**Business Unit:** Electronics **PCN/17/019/PM+MD-US**  
**Product range:** Circular Connectors Date: 2017-08-31  
**Title:** har-speed M12 Insulation Body Printing Page 1/3

**Details of Product Changes**

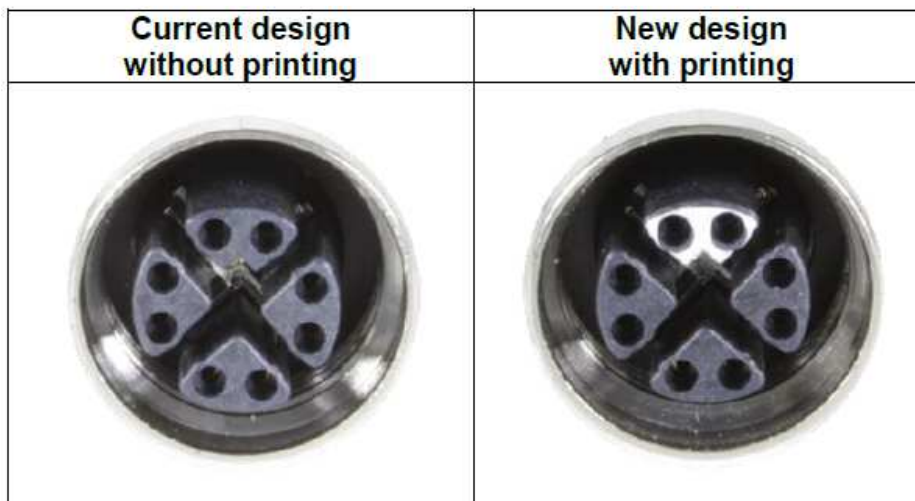
Implementation of improved visual indication of the coding position with white marking on the mating face of the M12 X-coded female connectors.
